Docket No. 50-423

Millstone Nuclear Power Station, Unit No. 3
Probabilistic Safety Study (PSS)

The above reference requested Northeast Nuclear Energy Company (NNECO) to submit additional information which resulted from the staff's review of information contained in Amendment No. 2 to the Millstone Unit No. 3 PSS. Enclosed please find documentation of all questions posed to NNECO along with our formal responses herein. We trust you will find this information fully responsive.

Figure 720.74-1
 Peak Acceleration Versus m_b
 at R=5 km

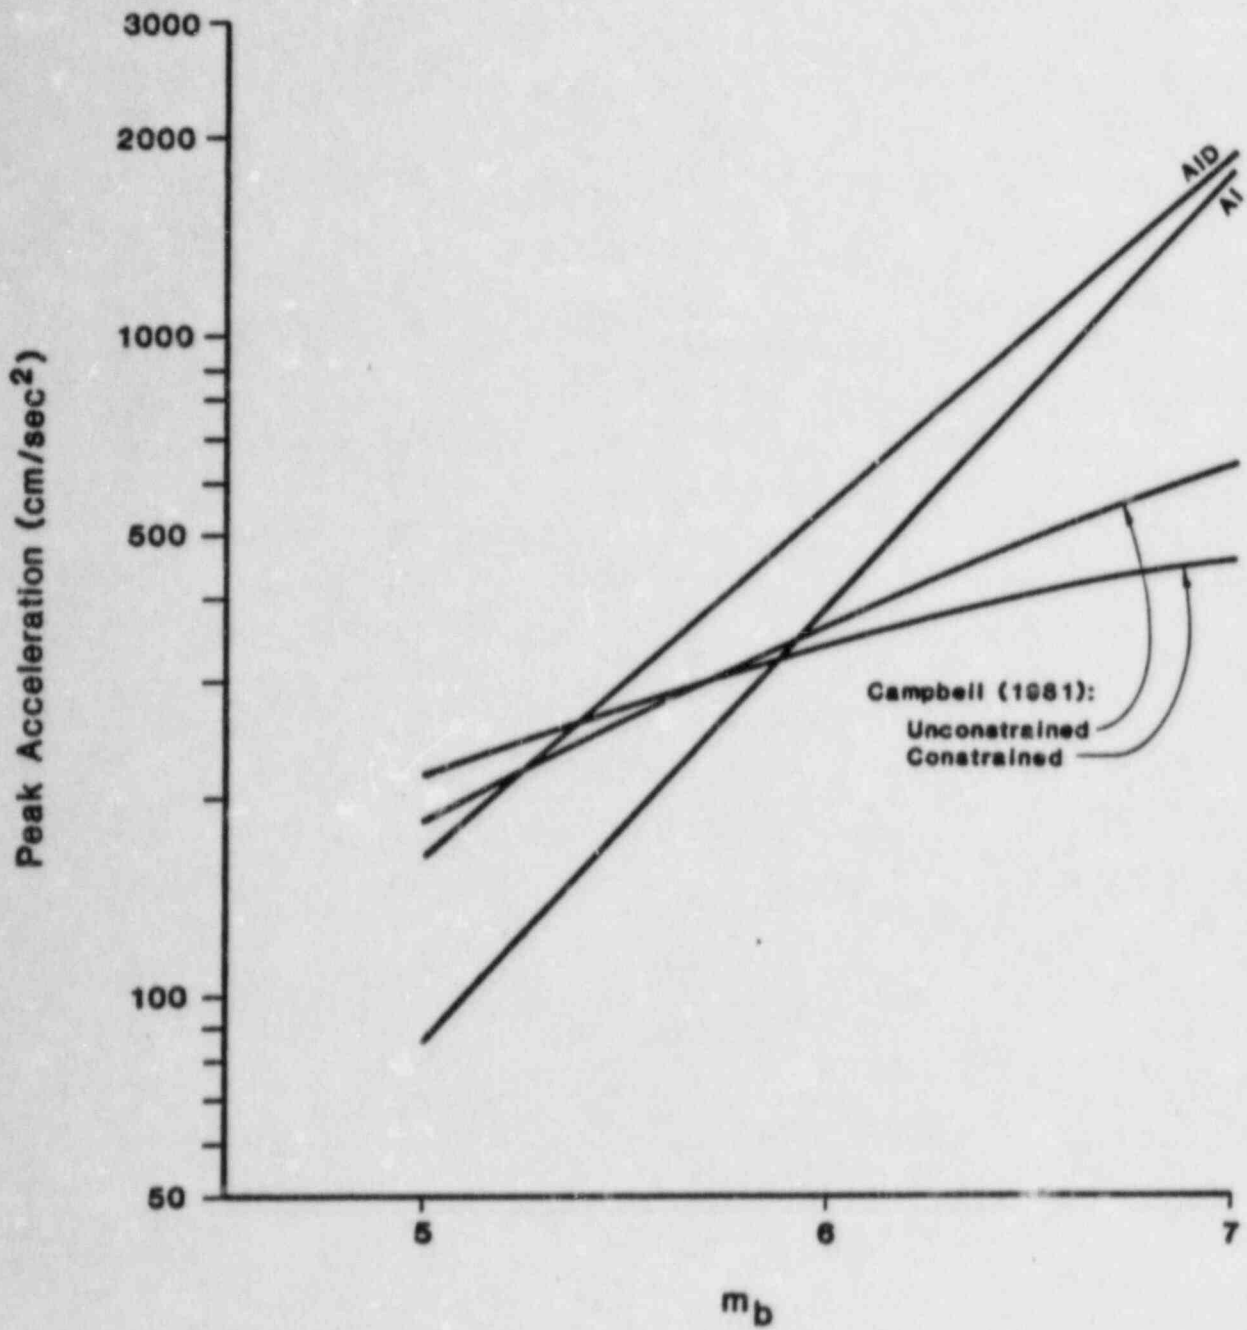
As reported in the Dames and Moore hazard report, two ground acceleration attenuation equations were derived from MM intensity attenuation using the relationship of Klimkiewicz (1982). The staff questions the validity of these relationships. These ground acceleration relationships predict lower near source accelerations for the same magnitude when compared to those of Campbell (1981a) whose near source eastern United States values are determined using near source western United States strong motion data.

- a) Why would near source ground motion (for the same m_b) be systematically lower in the east compared to the west, as you have assumed for these two equations?

Figure 720.74-1 shows a comparison between estimates made using the AI and AID attenuations, and those from Campbell (1981b), using both his 'constrained' and 'unconstrained' models for California. These estimates are made at a distance of 5 km (epicentral distance in the case of AI and AID, surface fault distance in the case of Campbell). Figure 720.74-2 shows a similar comparison at a distance of 10 km. This indicates the same general results. To make a comparison on the basis of m_b , the conversion from moment magnitude to m_b recommended by Campbell (1981a) was used.

Peak accelerations from the AID equation equals or exceeds Campbell's near estimates at all magnitudes above 5.3, and the peak accelerations AI equation exceeds Campbell's estimates at magnitudes above 5.8. For Millstone 3 the majority of seismic hazard comes from magnitudes above 5.5, and therefore the higher accelerations predicted by the AI and AID equations is conservative. In that little seismic hazard comes from earthquakes of magnitude less than 5.5 there is no significant effect on seismic hazard risk from Campbell's accelerations being higher than the AI and AID accelerations.

Noting the reasoning stated above and the information presented in Figures 720.74-1 thru 720.74-3 it is clear that the range of attenuation functions used in the Dames & Moore report is adequate to characterize the seismic hazard for Millstone 3.

Figure 720.74-4

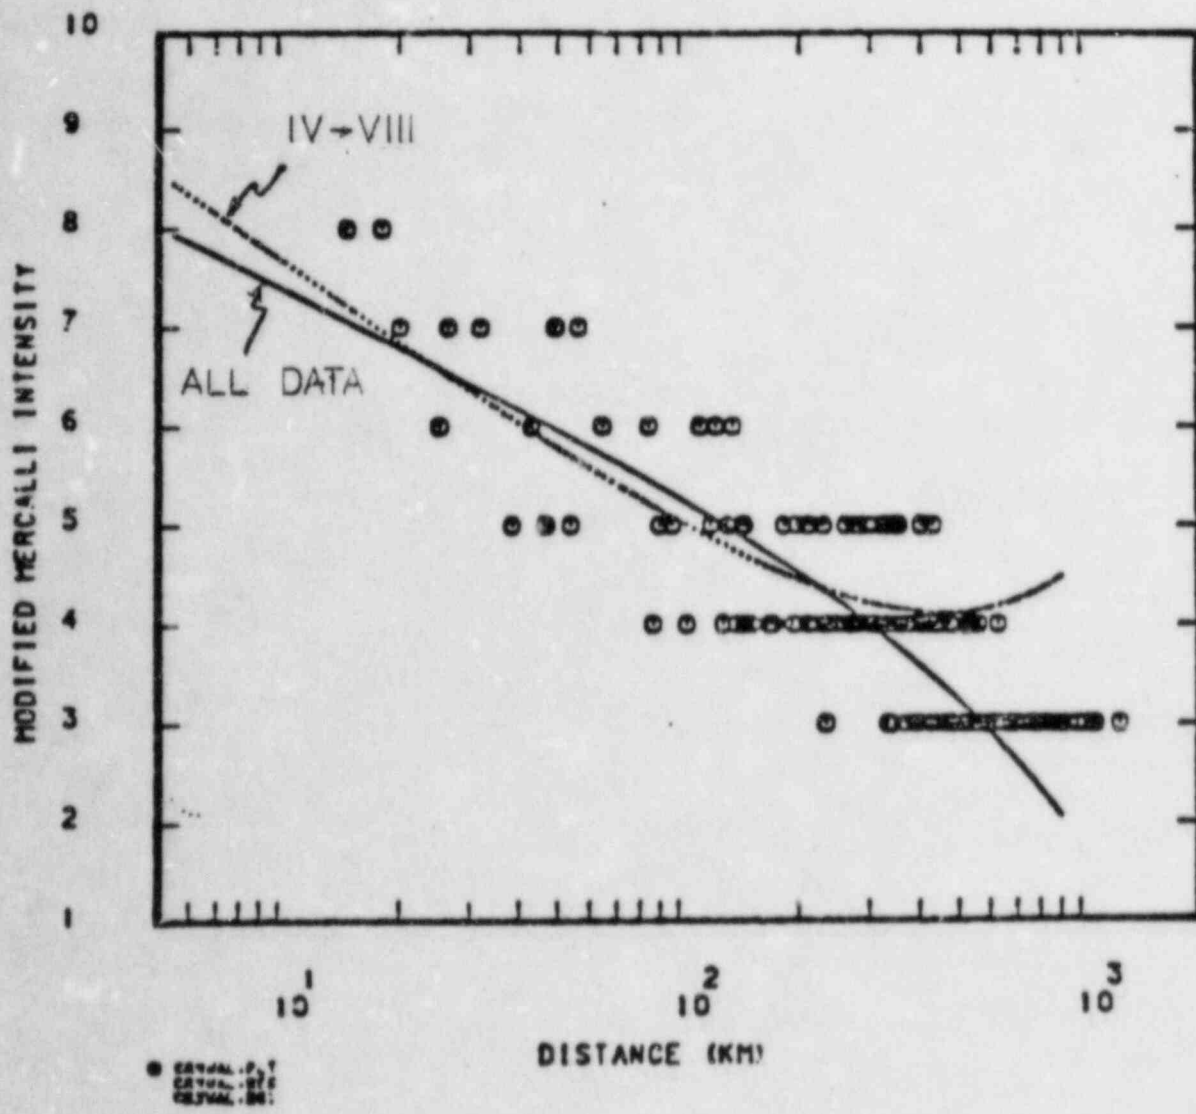
The staff is concerned that the intensity attenuation of Klimiewicz, (1982) is strongly influenced by intensities less than MMI=IV. It is likely that ground motion is not linear with MM intensity (see for example actual results of Trifunac and Brady, 1975, Murphy and O'Brien, 1978). Weston Geophysical has noted in the New Brunswick earthquake report (pg. 138) that the intensity attenuation model may be low for near epicentral distances. If intensities less than MMI=IV were removed from the intensity-distance set, would the intensity attenuation equation and thus the two ground acceleration attenuation equations result in higher seismic hazard curves compared to those assumed? If so, revise your seismic hazard curves accordingly.

In lieu of performing an analysis on all intensity data available for the northeastern US, it is more informative to show the effects of removing some intensities from the data set using just one earthquake. Figure 720.74-4 shows intensity data from the 1944 Cornwall-Massena earthquake, which has one of the least disperse sets of observations in northeastern North America. The solid line is a fit using all the plotted data; the dotted line is fit through intensities IV and above. It should be noted that intensities plotted as III are an undifferentiated combination of intensities I through III.

At distances less than 15 km and greater than 300 km the predictions of the two models differ. The dotted curve which excludes ground motion less than intensity IV is obviously incorrect when it shows increasing intensity at greater distances. At close distances (less than 15 km) there are no data to support either model, but theoretical considerations clearly give more weight to the solid curve by the following reasoning.

We conclude that the exclusion of intensity data less than IV would not provide better estimates of intensity for northeastern US earthquakes. The results presented in the response to question 720.74-1a confirm that the Klimkiewicz (1982) intensity equation is appropriate for estimating seismic ground motions in northeastern North America.

Figure 720.75-1

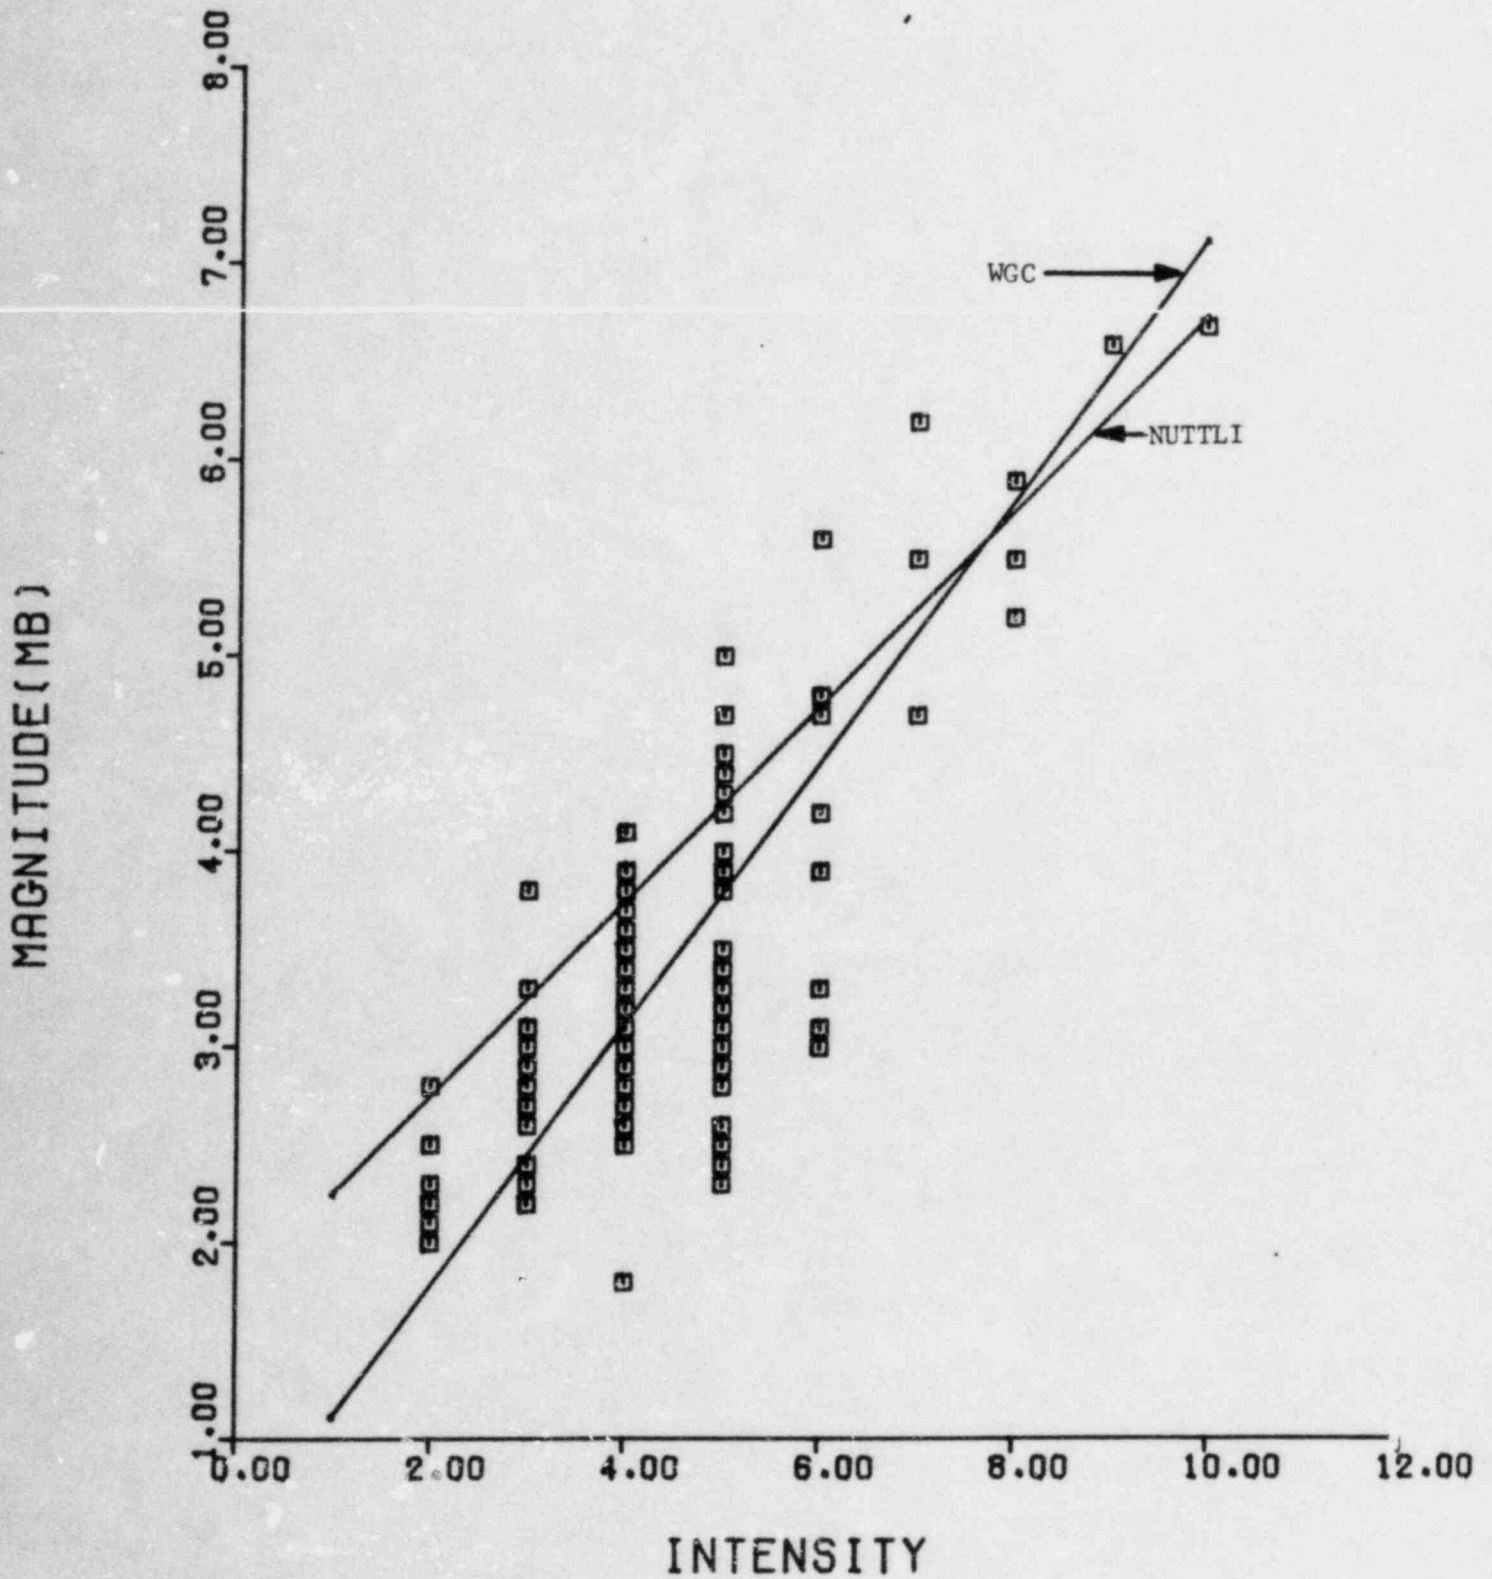
As noted in the attached internal staff memorandum (Enclosure 2), the staff questions the validity of the Weston (1982) epicentral intensity to magnitude equation. This equation is given a weight of 50% in your hazard analysis. Provide a response to the concerns in the attached memorandum, and if necessary, revise the seismic hazard curves assumed in your analysis.

The most appropriate equation to use to convert Modified Mercalli Intensity (MMI) to body wave magnitude (m_b) in the northeast is not resolvable theoretically, because intensity is an observed, empirical quantity. Some insight into the appropriate conversion can be obtained by examining all available earthquake data for the northeast that have both an instrumentally measured magnitude (m_b) and an assigned epicentral intensity. Table 720.75-1 is a listing of events meeting this criteria. These events are compiled primarily from the Chiburis catalog with additional events from Street and Turcotte and Yankee Atomic Electric Company Report #1331 (YAEC #1331). The events from YAEC-1331 come from the Weston Geophysical Corporation (WGC) catalog, and in particular are a subset of the events used in determination of the WGC conversion that are not found in either the Street or Chiburis data set. Figure 720.75-1 shows a plot of epicentral intensity versus body wave magnitude (m_b) for these events, along with the Nuttli and WGC intensity to magnitude conversions.

As a result of these comparisons, the procedure used in the Dames & Moore report is justified. Specifically, the data from New England do not allow differentiation between the Weston Conversion and the Nuttli conversion, and it is appropriate to weight each equally.

Figure 720.76 -1
Acceleration Hazard Curves

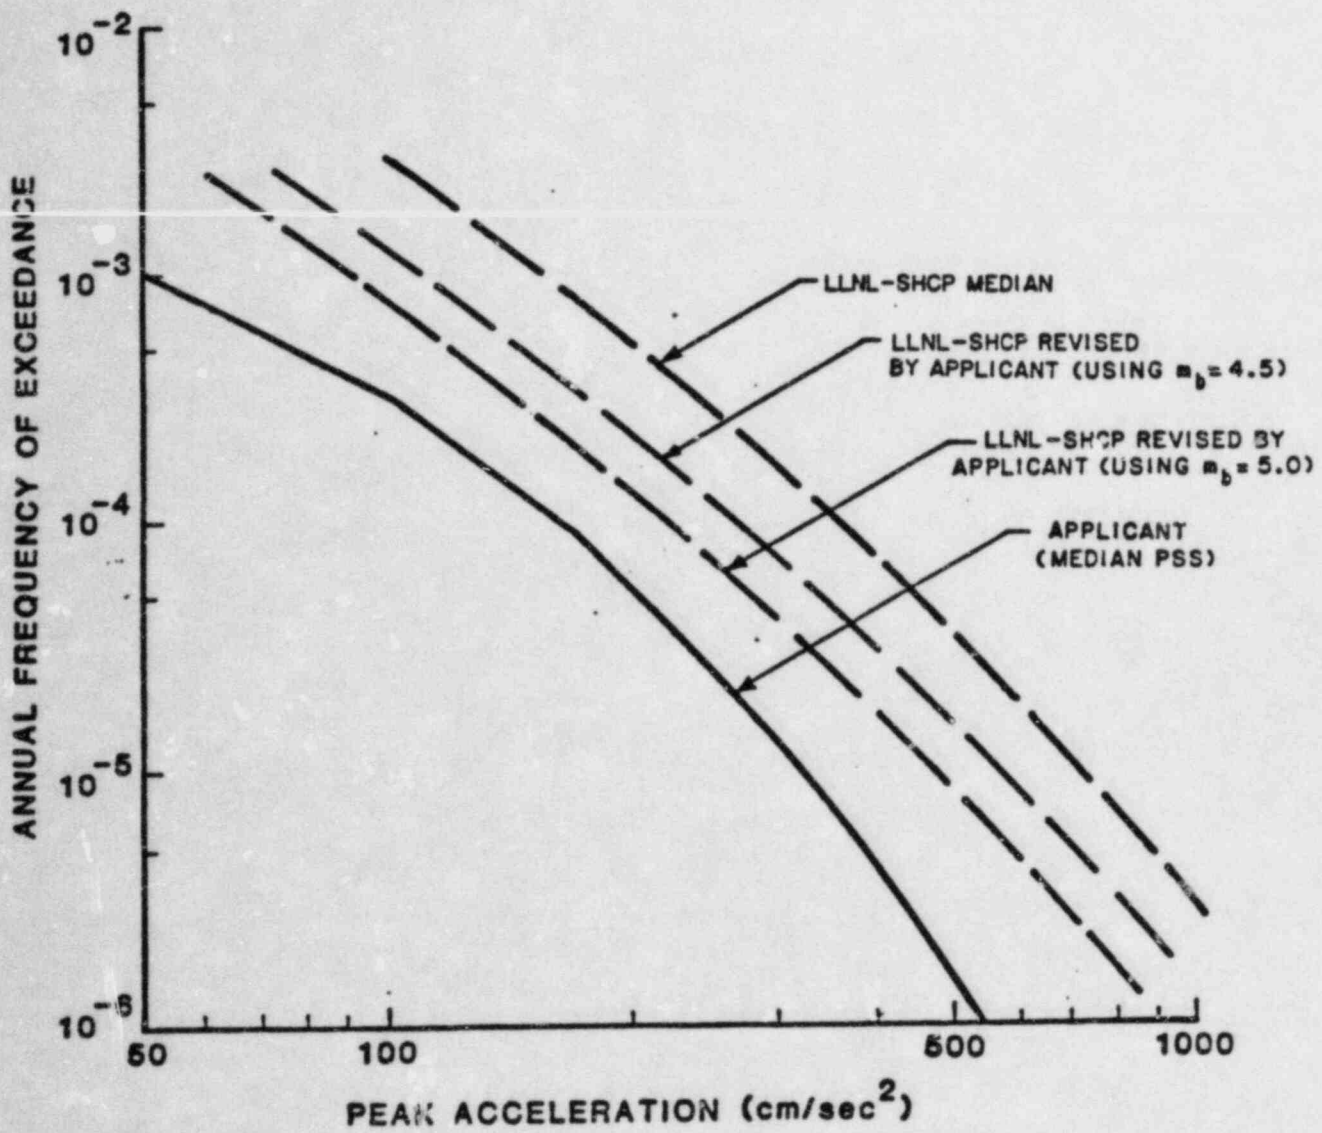
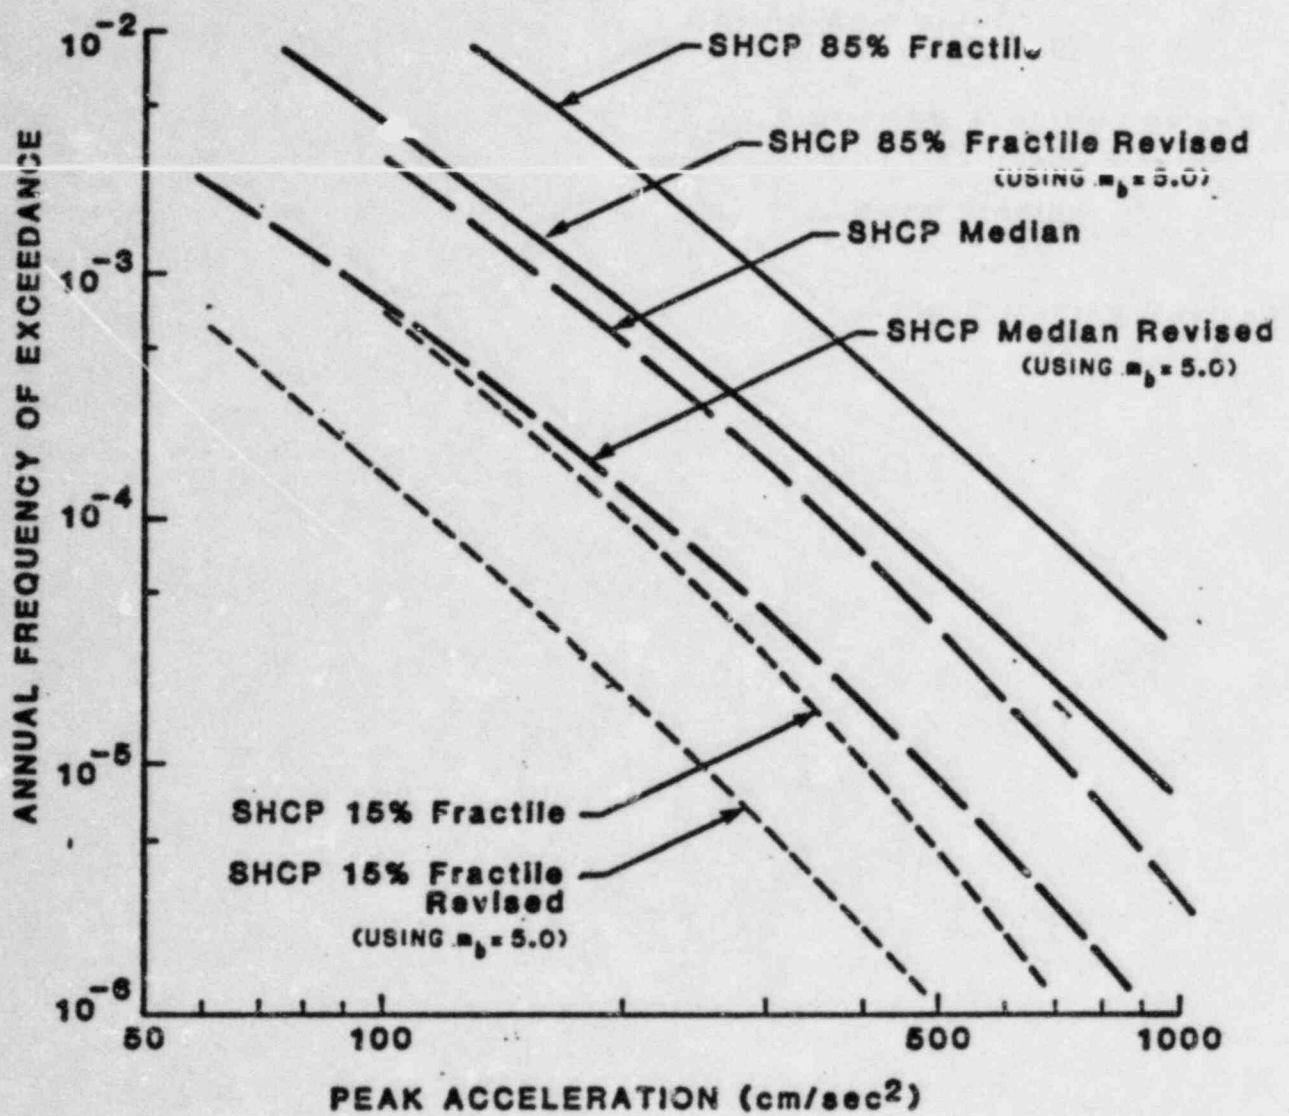
As part of an ongoing joint NRC Office of Research and Office of Reactor Regulation effort, the staff is assessing the seismic hazard for all nuclear power plants east of the Rocky Mountains. The Millstone site is included in the first ten sites. Results are discussed and displayed in NUREG/CR-3756, a copy of which was forwarded to you. The hazard results in NUREG/CR-3756 are significantly more conservative than you have assumed in the PSS.

- (a) The staff requests your comments on the above report, particularly with respect to differences between LLNL seismic hazard assumptions and those which you have used.
- (b) If there is any information in this report which would alter your hazard assumptions provide revised seismic hazard curves.

Thus, removing the major conservatisms identified in a preliminary review of the LLNL work means that the spectral amplitudes for a given probability level would decrease by 33% to 43%. A visual representation of the effect is shown on Figure 720.76-1. The peak ground acceleration hazard curve developed by the Applicant is shown as the solid line, and compared to it are several original and revised hazard curves from the LLNL study. The long dashed curves are LLNL median curves, as originally published and as revised by reducing the accelerations at a given probability level to remove the conservatisms discussed above. These reduction factors are shown in Table 720.76-1. The revised median curves lies much closer to the Applicants result. An original and a revised LLNL 15% fractile curve is shown in Figure 720.76-2. The revised curve clearly encompasses the Applicants curve, meaning that the Applicants results and the LLNL revised median results match within one-half standard deviation of the uncertainty in the hazard curves.

With these preliminary revisions, it is clear that the LLNL study results are consistent with those of the Applicant, given the uncertainty in seismic hazard calculations. There are strong scientific justifications for the revisions we describe; use of the original LLNL results to evaluate seismic safety at Millstone is inappropriate, given the preliminary and conservative nature of the LLNL results.
